INDESIT company

Model type:
WT67EU

Commercial code:
F026970

n1040245: Brembate washing machine basket doors re

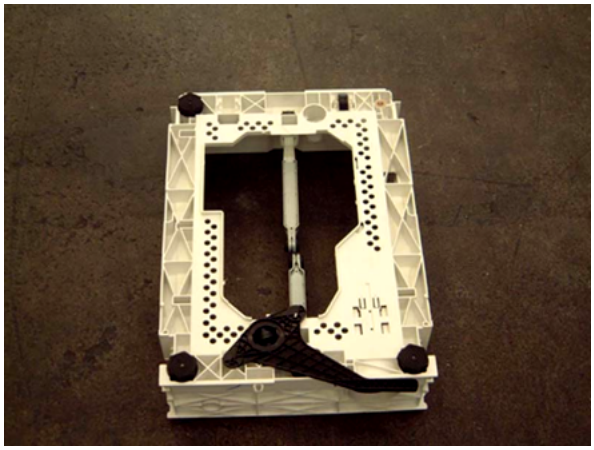
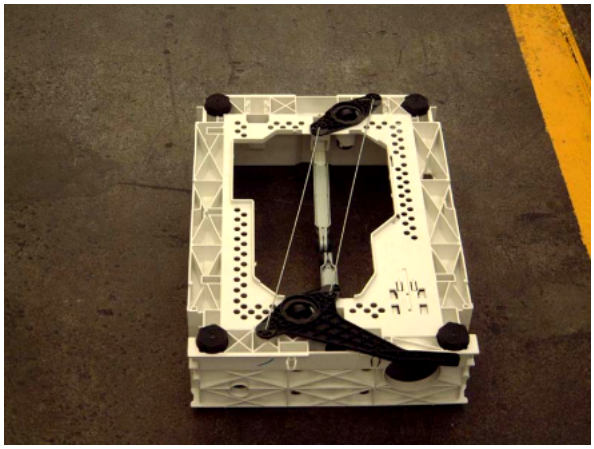
For all washing machine models produced in the Brembate factory and relevant to this note, in replacing the loading mouth code 083895/112743/252375 proceed as follows:
-remove the 18 rivets (9 on the right, 9 on the left) hooking the two doors to the loading mouth on the machine;
-take replacement part 083895/112743/252375 and carry out the same operation described in the previous point;
-hook the two new doors and the new loading mouth on the basket of the machine using the nut and bolts kit code 080691 (formed of 18 screws + 18 washers + 18 nuts);
-use silicone (SAT code 081629) for hooking the loading mouth on the basket.

FIG. 1

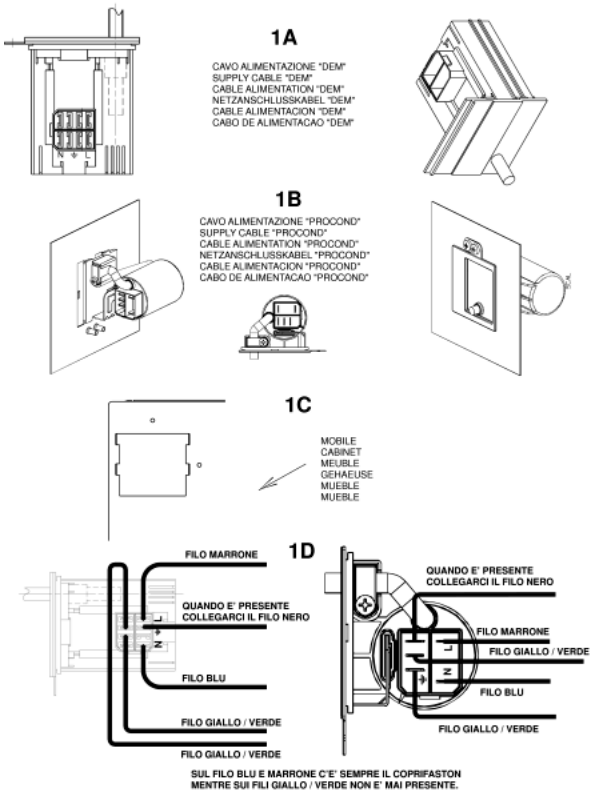
To use premodified wirings on modified products perform the connection to the terminal block of the new cable as shown in fig. 1 - 1D.
The wiring diagrams indicated in the Documentation remain the same.

N1040309FIG1

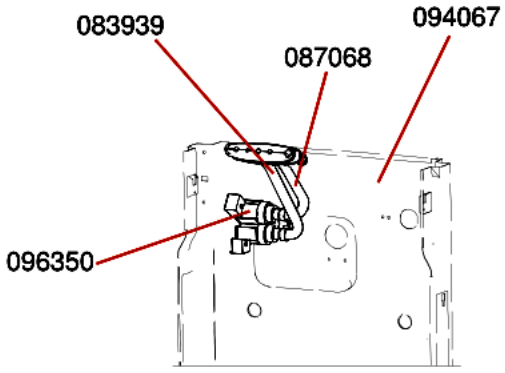
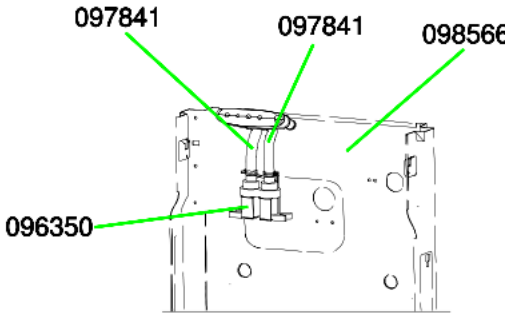
From serial no. 30912.0001, the system used for fixing the loading solenoid valve (spare part code 096350) to the rear panel has been modified on Top Loading washing machines, rotating its position by 90°.
The solenoid valve (spare part code 096350) has been modified with the 45° rotation of a coil; the Replacements Warehouse will continue to manage this part with the same code. When replacing on premodification machines, fit the coils as shown in figure N1040309FIG3-1 and on modified machines, as shown in figure N1040309FIG3-2; to rotate the coil, lift it using a screwdriver and then refit according to the inserts on the plastic.

Replacement codes of the parts affected by this modification (see figure N1040309FIG1):

FIG1 A - PREMODIFICATION STRUCTURE
solenoid valve tube/distributor assembly: premodification 083939;
solenoid valve tube/distributor assembly: premodification 087068;
rear panel: premodification 094067.
FIG1 B - NEW STRUCTURE

solenoid valve tube/distributor assembly: new 097841;
solenoid valve tube/distributor assembly: new 097841;
rear panel: new 098566.

N1040309FIG2

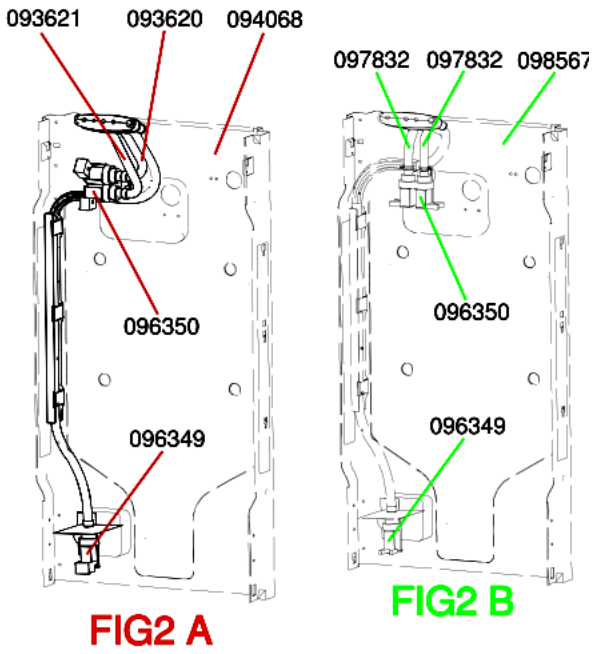
Replacement codes of the parts affected by the modification to WMTL80UK (see figure N1040309FIG2):

FIG2 A - PREMODIFICATION STRUCTURE
solenoid valve tube/distributor assembly: premodification 093620;
solenoid valve tube/distributor assembly: premodification 093621;
rear panel: premodification 094068.
FIG2 B - NEW STRUCTURE
solenoid valve tube/distributor assembly: new 097832;
solenoid valve tube/distributor assembly: new 097832;
rear panel: new 098567.

n1040321: Plastic protecion for solenoid valve.

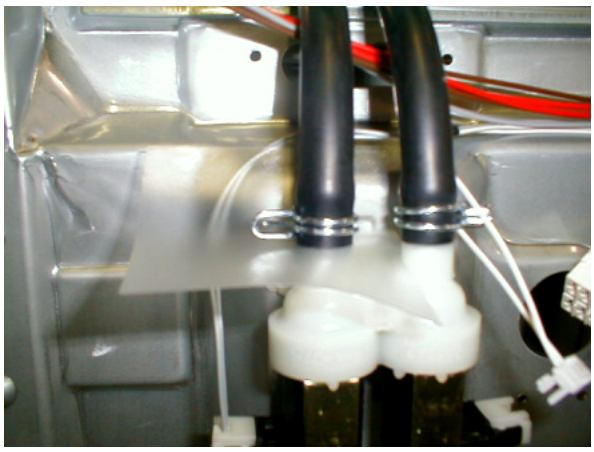
All top-load washing machines produced from September 2003 to February 2004 (from serial no. 30900.0000 to 40300.0000) have been equipped with a plastic protection Service code 109798 (shown in N1040321FIG1), to prevent water from damaging the solenoid valve and electronic card.

N1040324FIG1

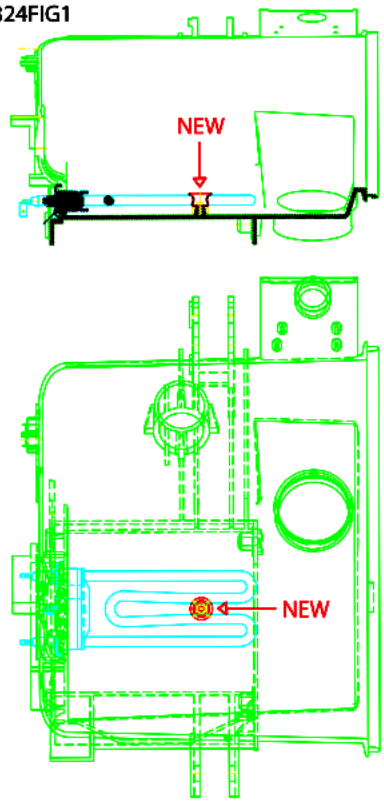
From serial number 40506.0001, the fixing system of the heater to the tank has been modified on all top-load washing machines affected by this note, with the introduction of a metal retainer (image N1040322FIG1 reference NEW) in place of deflector Service code 055322.

The modification has involved both heater and tanks. Given below are the Service codes of the new and old items concerned:

-PLASTIC TANK FOR 600-1000 RPM MACHINES: new 110152, premodification 083805;

-PLASTIC TANK FOR 1200 RPM MACHINES: new 110153, premodification 092023;

-HEATER: new 110148, premodification 083906.

N1040404FIG1

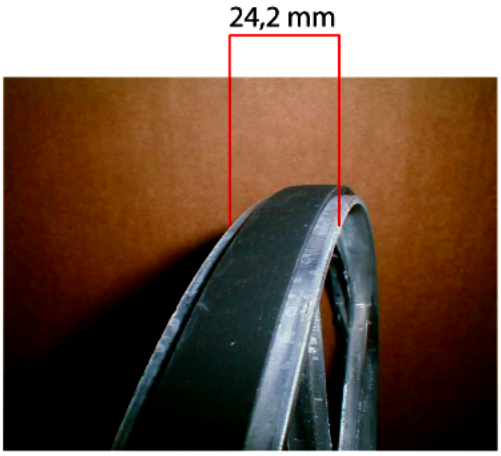
From serial no. 51202.0001 the pulley track has been widened from 21.2mm to 24.2mm (see picture N1040404FIG1).

new pulley
C00142832 - D280 24.2 mm track

Premodification pulley
C00083912 - D280 21.2 mm track

The new pulley can also be used on premodification versions of the models referred to in this release.
